APPENDIX D

REGIONAL MODEL AND CONFIDENCE BUILDING (RESPONSE TO USFIC 5.02, USFIC 5.12, AND USFIC 5.11 AIN-1)

This appendix provides a response for Key Technical Issue (KTI) agreements Unsaturated and Saturated Flow Under Isothermal Conditions (USFIC) 5.02, USFIC 5.12, and an additional information needed (AIN) request on USFIC 5.11. These KTI agreements relate to providing more information about the use of the regional-scale model in the site-scale saturated zone flow model (SSFM) and the Solitario Canyon alternative conceptual model.

Figure D-8. Flow Paths from the Repository with Simulated Hydraulic Head Contours

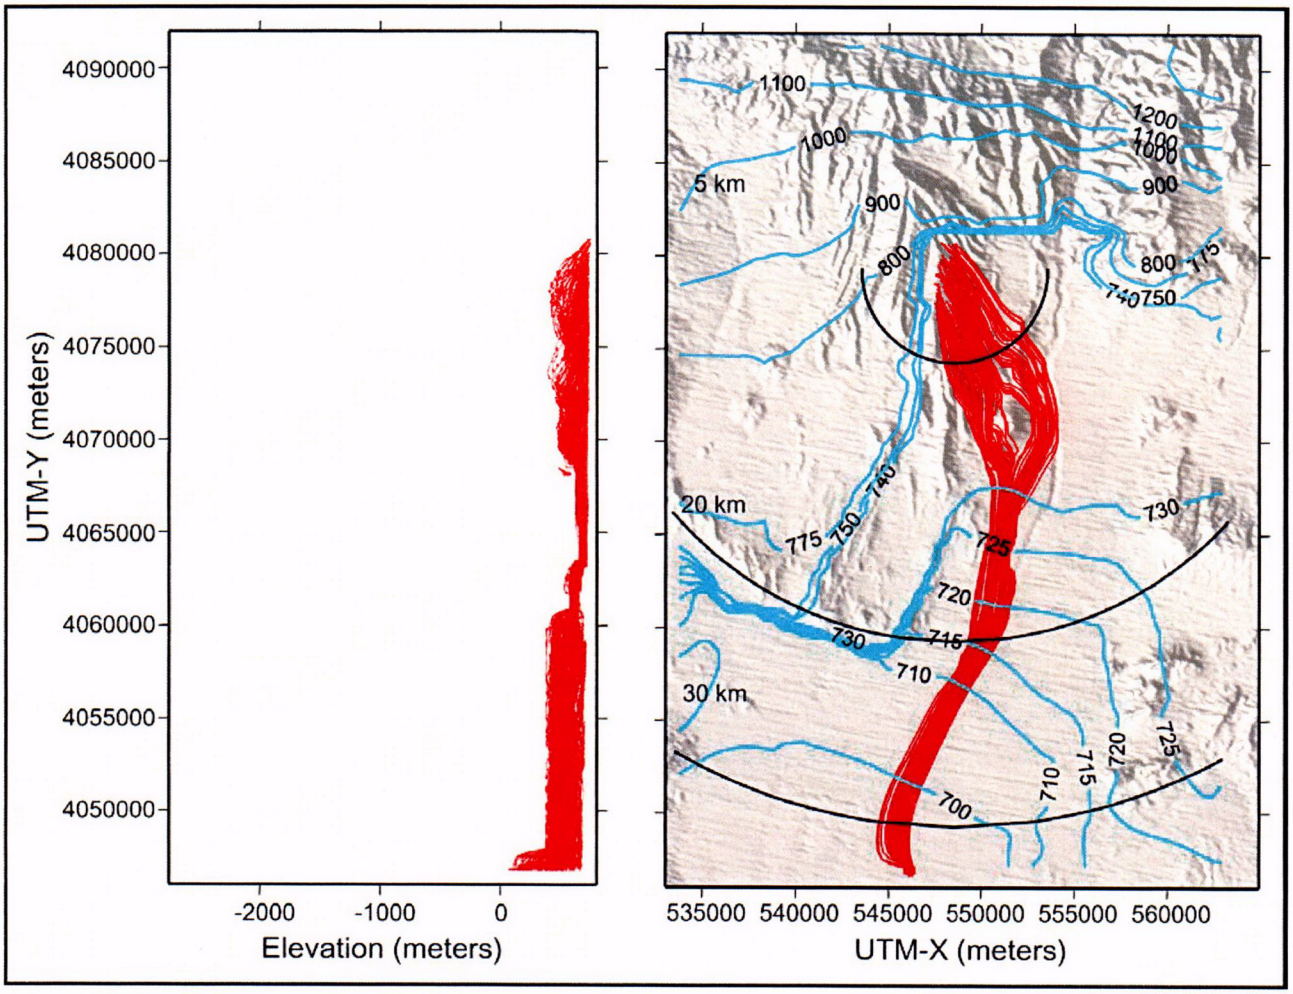
1. To examine flow and potential radionuclide transport in the deeper aquifer system, a vertical cross- sectional figure showing the flowpaths is needed. As an example, the left diagram of Figure 8 in the Calibration of the Site-Scale Saturated Zone Flow Model AMR (CRWMS M&O 2000) shows such a cross-sectional view. Two such particle tracking figures showing distance vs. depth are needed: one for the calibrated model and another for the shallow Solitario Canyon Fault alternative model.

2. To test the hypothesis that potential contaminant releases on the west side of a shallow Solitario Canyon Fault might enter the lower carbonate aquifer, DOE should provide an analysis of flow paths from the west side of a shallow Solitario Canyon Fault. Alternatively, DOE could provide an explanation of repository design and site characteristics that would preclude contaminant releases to the west side of the Solitario Canyon Fault.

Response to USFIC 5.11 AIN-1 (Comment #1 and Comment #2)–To investigate the importance of the depth of the Solitario Canyon fault, an alternative conceptualization was simulated in which the fault only extended from the water table to the top of the carbonate aquifer (BSC 2003a; see also Section D.4.3). This alternative, referred to as the shallow fault alternative model, was identical to the SSFM in all respects except for properties of the Solitario Canyon fault. The shallow fault alternative model only changed the computation grid where necessary to implement the alternate formulation of the fault. The shallow fault alternative model was calibrated in a manner identical to the SSFM. Areal and vertical slice flow paths for the different model scenarios are illustrated in Figures D-15 through D-18. For each of these figures, the left side shows the flow paths in vertical cross-section, and the right side shows the corresponding flow paths in map view.

Simulations using the two conceptualizations of the Solitario Canyon fault (original and alternate) produced essentially the same results, and the simulated water levels, hydraulic gradients, and transport pathways were little affected by the alternative conceptualization. Both conceptualizations yielded the same flow paths from the water table under the repository to the accessible environment, and transport times were not affected by the depth of the fault. The influence of reducing the depth of the Solitario Canyon fault on total system performance is expected to be minor. This alternative conceptualization resulted in no major changes to the flow system and has no consequences for radionuclide transport.

Based on current designs, the repository will be located east of the Solitario Canyon fault. A study of potential radionuclide flow paths in the unsaturated zone indicated that a negligible number of particles would reach the water table west of Solitario Canyon fault within the 10,000-year regulatory period. Therefore, the alternative conceptualizations of the Solitario Canyon fault have little effect on transport in the saturated zone.
